## ADDENDUM NO. 1

**DATE:** March 12, 2020  
**PROJECT:** IFB 2020-02 Lisbon Avenue Culvert Replacement Project  
**TO:** ALL PLAN HOLDERS

## Possible Yard Locations

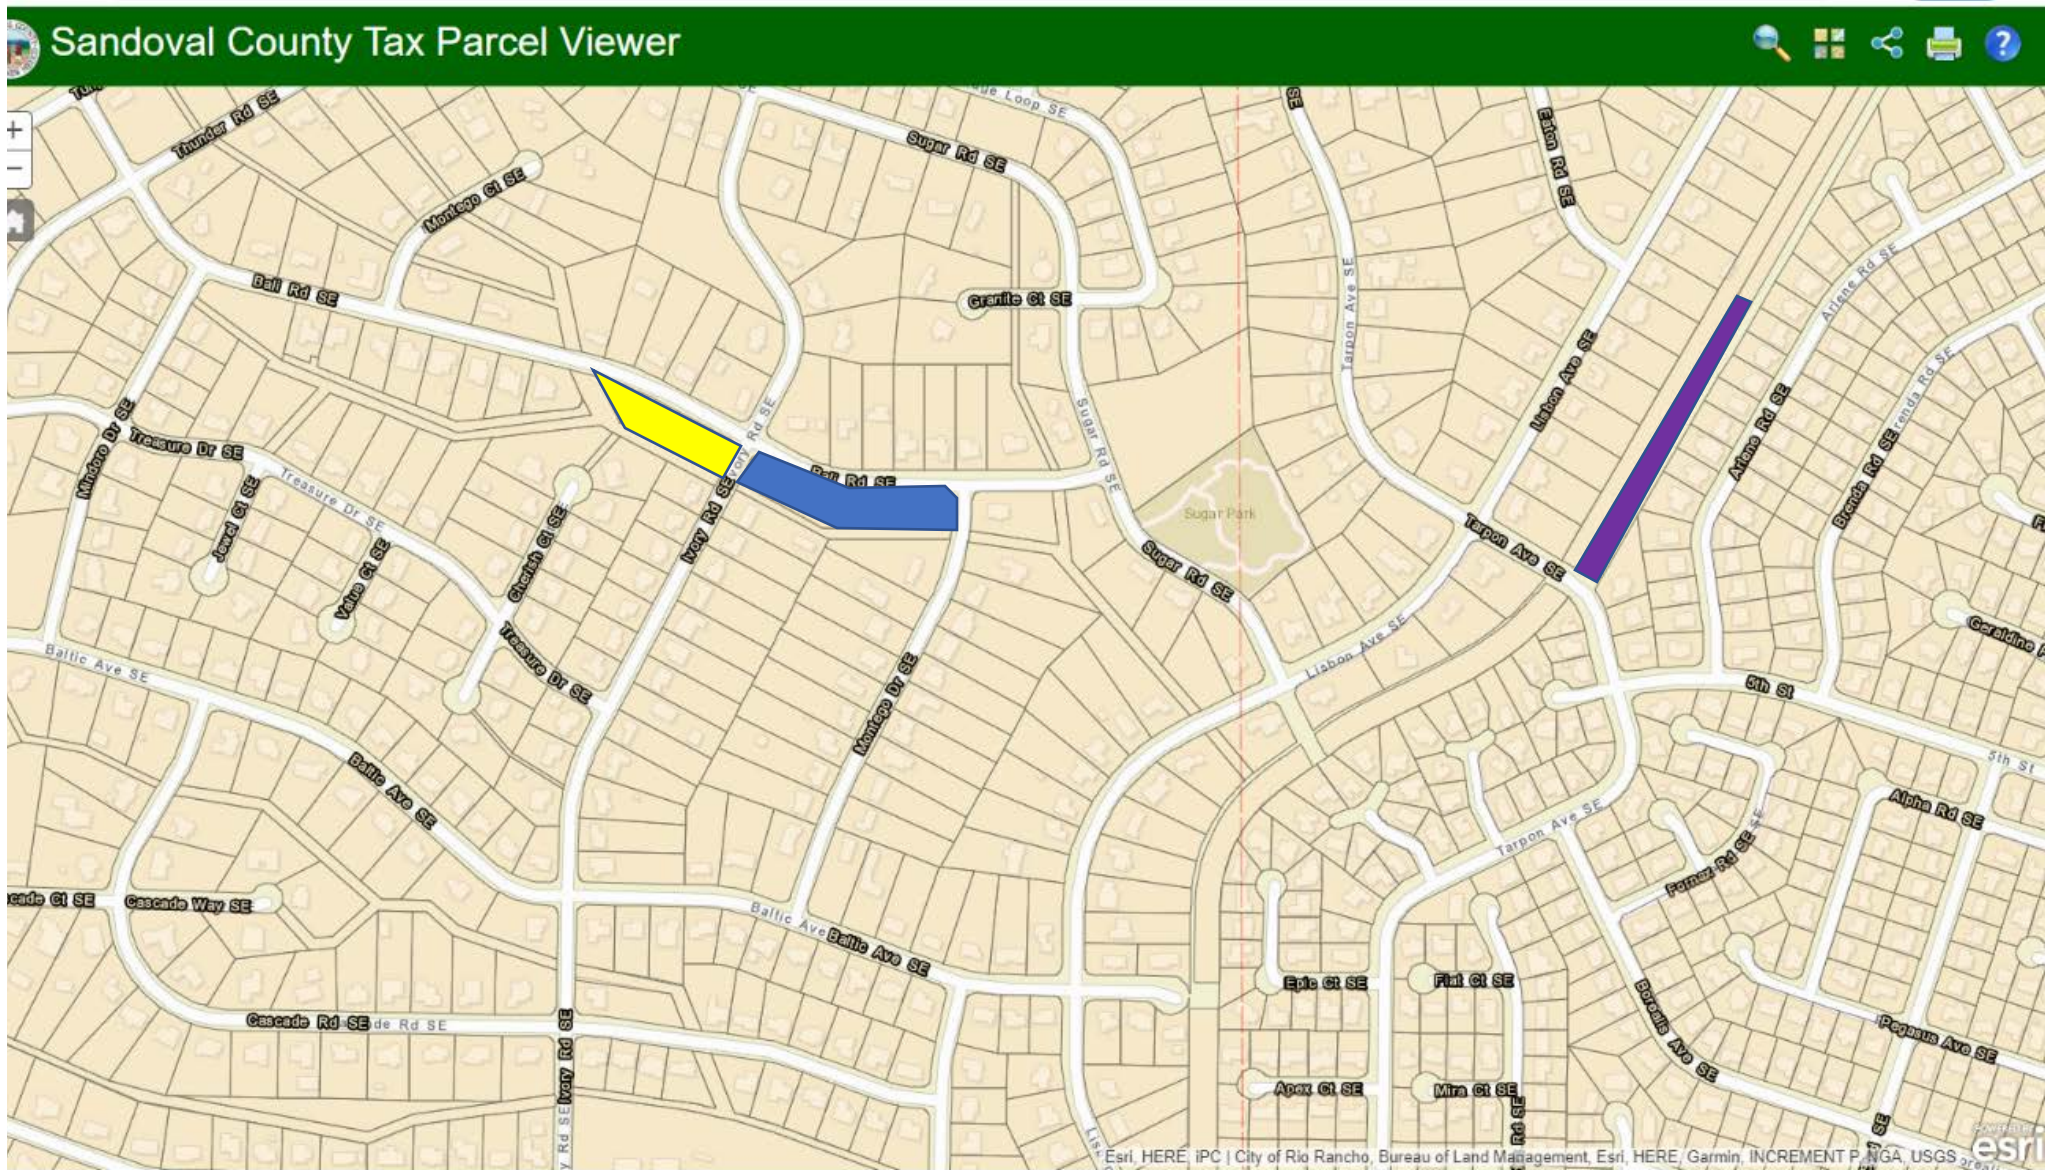
Q: *Is there a construction yard available for the Contractor use?*

A: Mr. Andy Edmonson, SCAFCA, discussed SCAFCA owned tracts in the general vicinity of the project area that may be used for construction yards.

Note: Access to non-SSCAFCA owned locations will need to be negotiated with the property owner.
